TS-SSC 91-063

**Subject:** Evaluation of collar lamination inspection report (SSC 50 mm collar lamination without shims, part# ME-292059 rev. C)

Figure 1

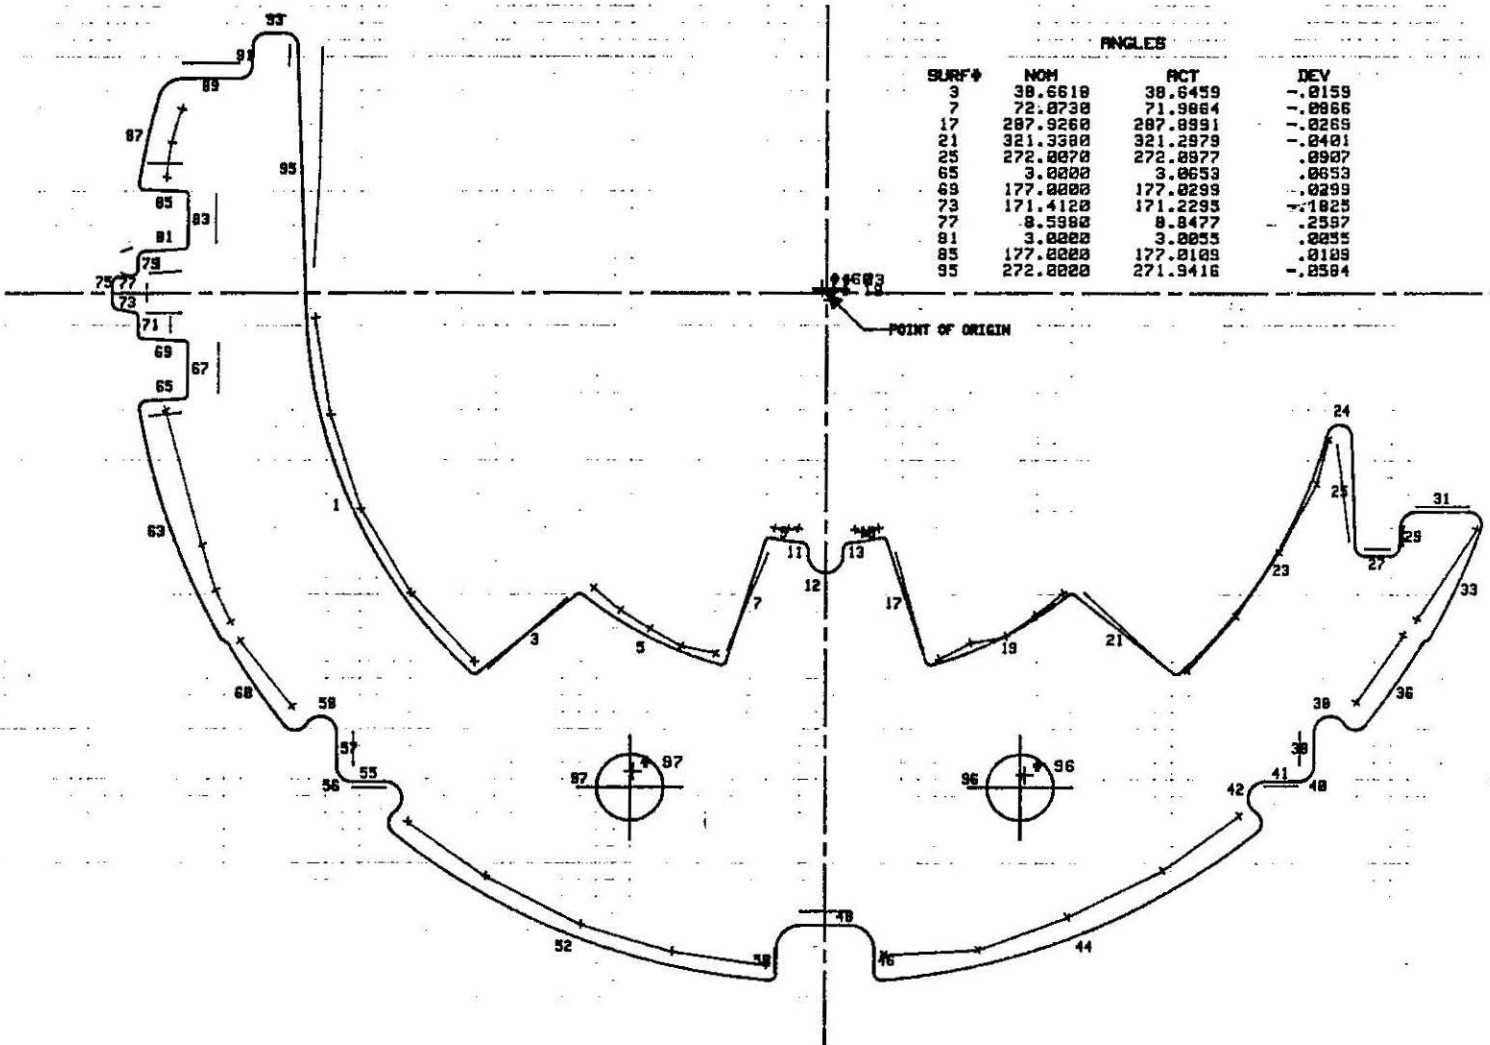
Figure 1 shows the optical contour projector inspection report for the revision C collars. The measured points for the collar interior match the design within a few tenths of a mil except along the long arm on the left which appears to be sprung inwards by about a mil at its tip. Since the slot into which this arm mates is very close to its design size and location, the sprung arm will tend to be forced to its design position, making the entire interior surface good to better than 0.5 mil. The active key surfaces (69 and 85) are translated up by a little over a mil. Thus the collar cavities, both for the inner and the outer coils, will be about 1 mil (per quadrant) larger than the design.

The "vertical" collar outer surface (33, 44, 52, 60) are shifted up by 1 mil. This shift is comparable to the shift in the key slots, so the undeflected collar diameters along these surfaces should be equal to the design within about a mil.

The fit between the collars and the tooling is set by the relation between the collar outer surface (principally surfaces 44 and 52) and the alignment flats (40 and 56). In a coordinate system set by surfaces 44 and 56, the alignment flats are shifted down by 1.5 mils, very close to the promised 2 mils. Because the "vertical" outer surface and the active key slot surfaces are both shifted up, the relationship between the two, which determines the amount of collaring tooling closure required for key insertion, is within a mil of the design.

The "horizontal" collar outer surfaces (33, 63 and 87) are designed to have an interference fit with the yoke. These are shifted inwards by about 1-1.5 mils. If the long arm on the left is moved closer to its design position under assembly, the "horizontal" outer surfaces are within a mil, although still shifted inwards, of the design. A modest inward shift is, in fact, desirable. The collar was designed[1] based on calculations[2] that indicated that the collar horizontal radius would decrease by about 0.5 mil under coil prestress. Experimentally the horizontal radius actually increases by 1-1.5 mils under prestress resulting in a horizontal yoke-collar interference up to 2 mils larger than called for in the design.

- In the first paragraph of "Evaluation of Rev. C Collar," how do you deduce the 0.5 mil?

- In the last paragraph of the same section you mention that "experimentally the horizontal radius actually increases under prestress." This probably refers to the last collar deflection measurements you made. Could you fax or mail me your data?

As shown on the inspection report the only part of the collar interior that deviates from the design by more than 0.5 mil is the vertical surface of the long arm on the left above the center line. Since this part of the collar does not contact the coil it is less important than the rest. Note, however, that the slot on the right into which the tab at the end of the long arm fits is, at its bottom, of the design width and position within a few tenths of a mil. Since the short piece on the right is much stiffer than the long arm on the left, when the two are mated it is the long arm that will deflect the match the short one. This will move the arm to the left forcing it to within 0.5 mil of the design location.

As I indicated to you in last week's confessions, much of the collar deflection data (alho not all of it) look unreliable. I am still trying to find time to evaluate it and hope to put out a tech note summarizing and analysing it within the next week or so. I would prefer to wait rather than having to send out data and then apologize for it later. Bug me in a week if you haven't heard from me on this subject.

Figure 2

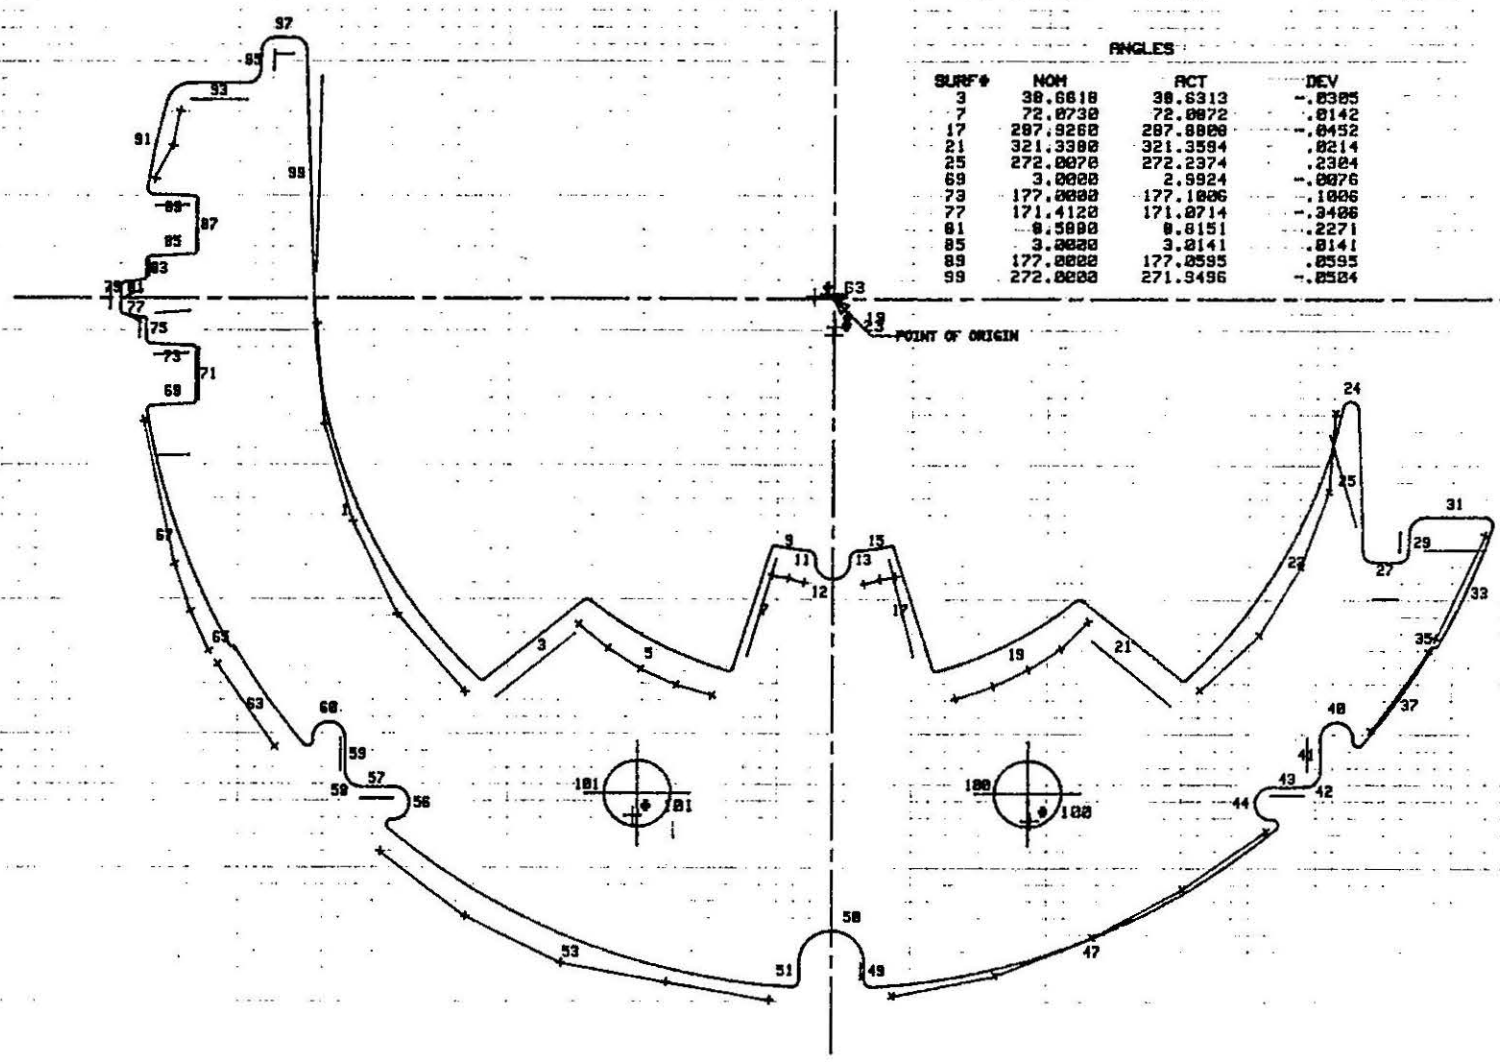
Figure 2 shows the optical contour projector inspection report for the revision A collars. The active key surfaces (73 and 89) are shifted down by about 0.5 mil and the entire collar interior (1, 3, 5, 7, 17, 19 21 and 23) is shifted down by 1.5-2 mils. In a coordinate system normalized vertically to put the key surfaces at the design position (these are the coordinates that describe the collars after they are keyed) the collar interior is shifted down by an average of a bit over a mil. Therefore the coil cavities are a little over a mil larger than the design size. The difference between the coil cavities of the revision C and revision A collars is less than a mil and is probably zero within the measurement accuracy.

Normalized to the "vertical" outer surface (47 and 53) the active key surfaces are within a few tenths of a mil of the design. This is the same within the probable measurement accuracy as for the revision C collars. Thus the revision C collars will require about the same compression for key insertion as used for the revision A collars. Normalized to the "vertical" outer surface the alignment flats are within a few tenths of a mil of the design. Relative to revision A, therefore, the revision C collar flats are about 4.5 mils closer to the tooling which will eliminate the current need for 5 mil shims on these surfaces.

On the revision A collar the "horizontal" outer surfaces (33, 67 and 91) are radially shifted relative to the design by from -1 mil (surface 91) to +1 mil (surface 67). On the average these surfaces on the revision C collar are at a radius 0-1 mil smaller than on the revision A collars. This is desirable, as noted above, since it will result in a fit between the collared coil and the yoke that is closer to the design.

- In the second paragraph of "Comparison with Revision A" you refer to the vertical outer surface. Do you mean the "design" surface or the "actual" one.

- At the end of the same paragraph, we cannot make out the 4.5 mils number you give.

"Normalized to the 'vertical' outer surface" means that all the measured points are moved upwards until, on the average, the measured points on the "vertical" outer surface lie on top of the design. Then the comparison between measured and design locations of the the key slots and alignment flats is made.

Between Revision A and Revision C the design location of the alignment flats was moved down by 3 mils. In the Revision A collars the flats, relative to the "vertical" outer surface, are at their design location with measurement error. In the Revision C collars the flats, relative to the "vertical" outer surface, are down by 1.5 mils from the design location. Thus the net change in the position of the flats relative

to the "vertical" outer surface is  $3 + 1.5 = 4.5$  mils.

Figure 3

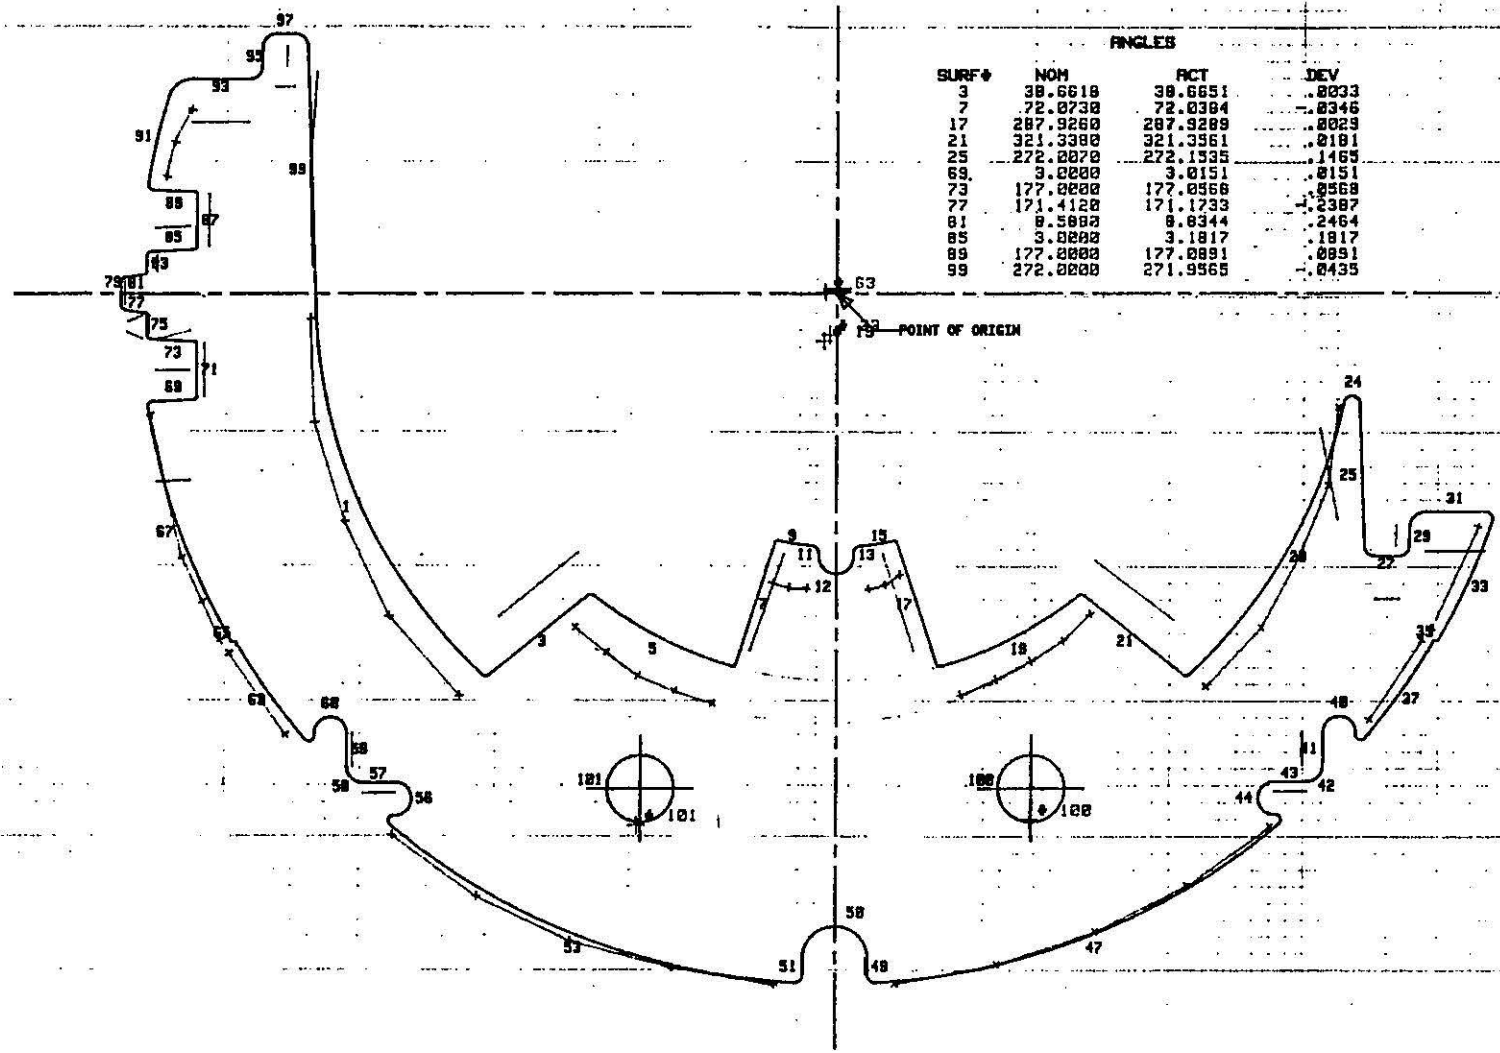
It should be noted that the initial inspection of the revision A collars was made with respect to an incorrect version of the revision A drawing, which had the outer coil pole surfaces shifted by 5 mils away from the mid-plane in a direction perpendicular to the pole surface relative to the correct drawing. According to Steve Merkler this error was corrected on 10/4/90. Any inspections done before this are incorrect and the corresponding reports should be discarded. An example incorrect inspection report is attached as Figure 3.
